Service Manual

SE-VC1180

- Notes:**
- This service manual is provided to indicate the main differences between the original model No. SE-CA1080 (E) and the subsequent model No. SE-VC1180 (E, EB, EG).
 - Refer to the Connections, Quick reference of remote control operation and Preparing of the remote control of Service manual for Model No. SL-VC1180 (E), Order No. AD9506160C2.

CHANGES

SCHEMATIC DIAGRAM (SE-CA1080 Service Manual of page 8.)

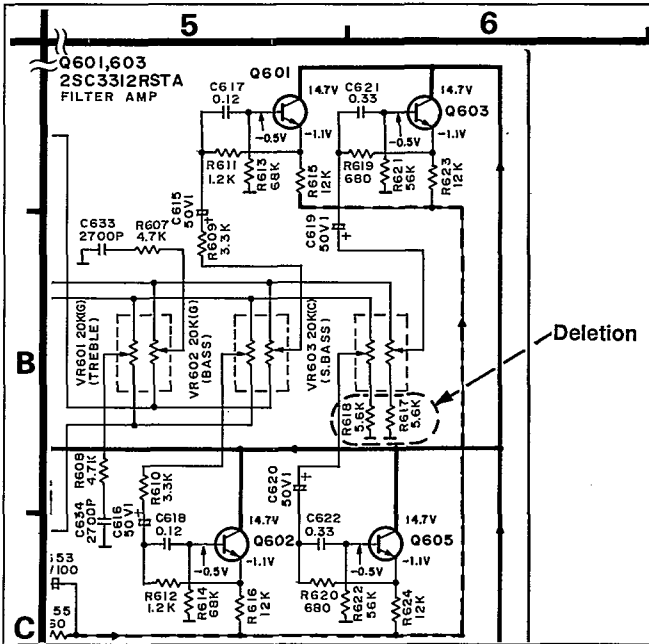
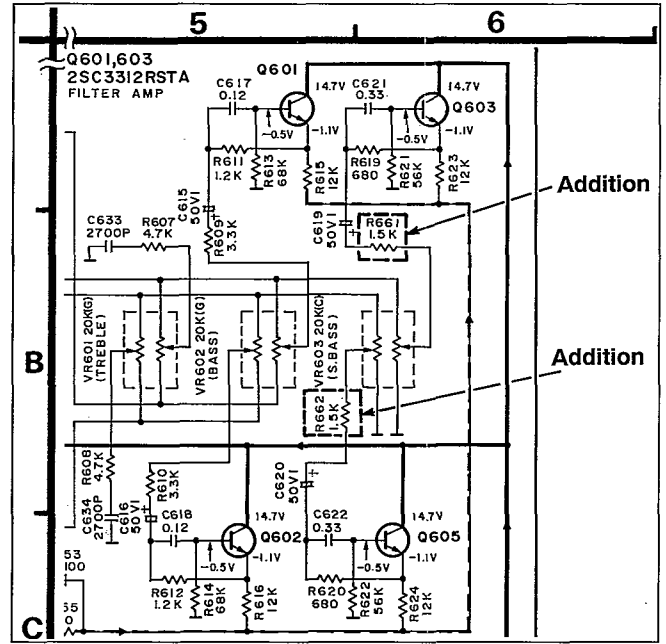
Note: Those parts have added.

A OPERATION CIRCUIT

PRINTED CIRCUIT BOARDS (SE-CA1080 Service Manual of page 14.)

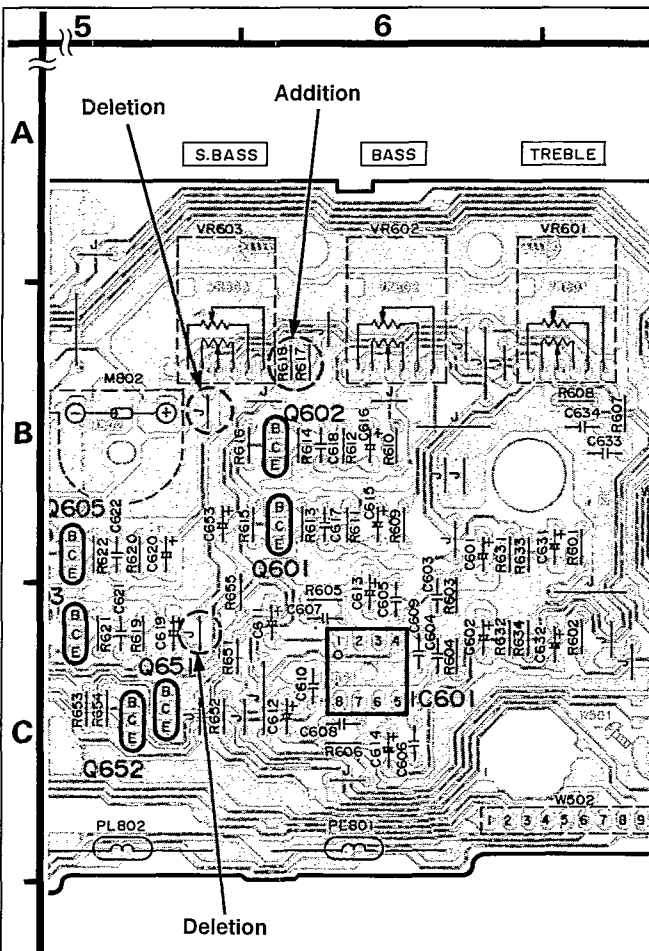
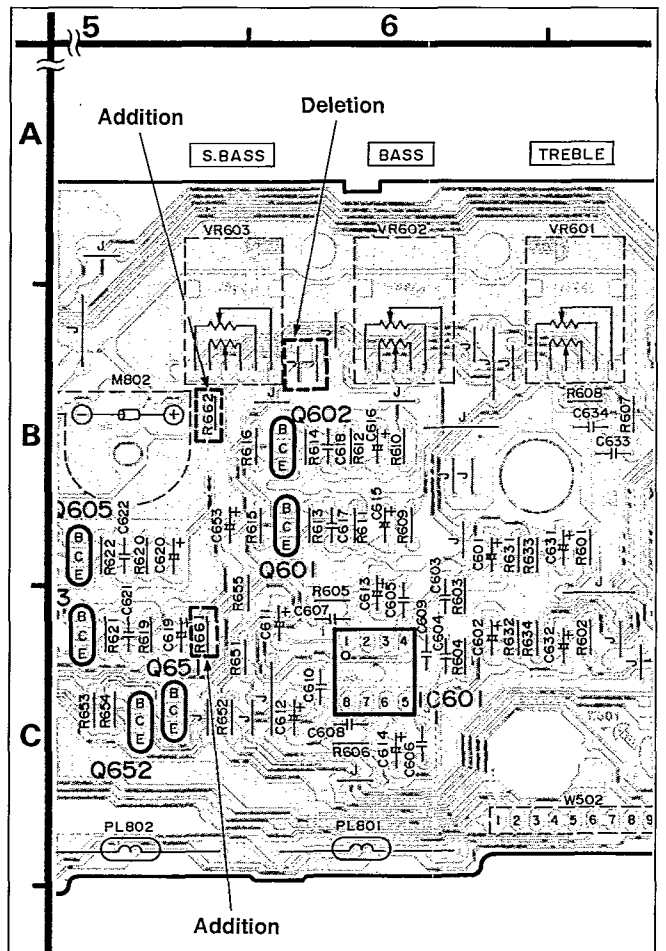
Note: Those parts have added.

A OPERATION P.C.B. (REP1924B-S)

CABINET PARTS LOCATION (SE-CA1080 Service Manual of page 16.)

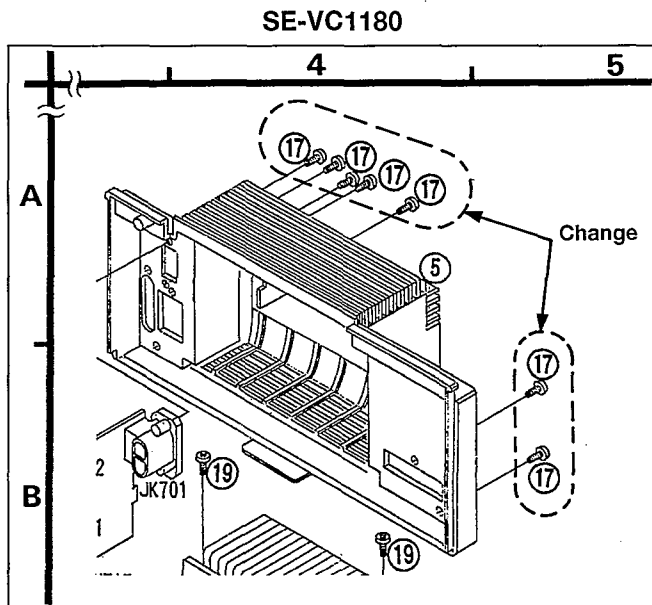
Note: Those parts have changed.
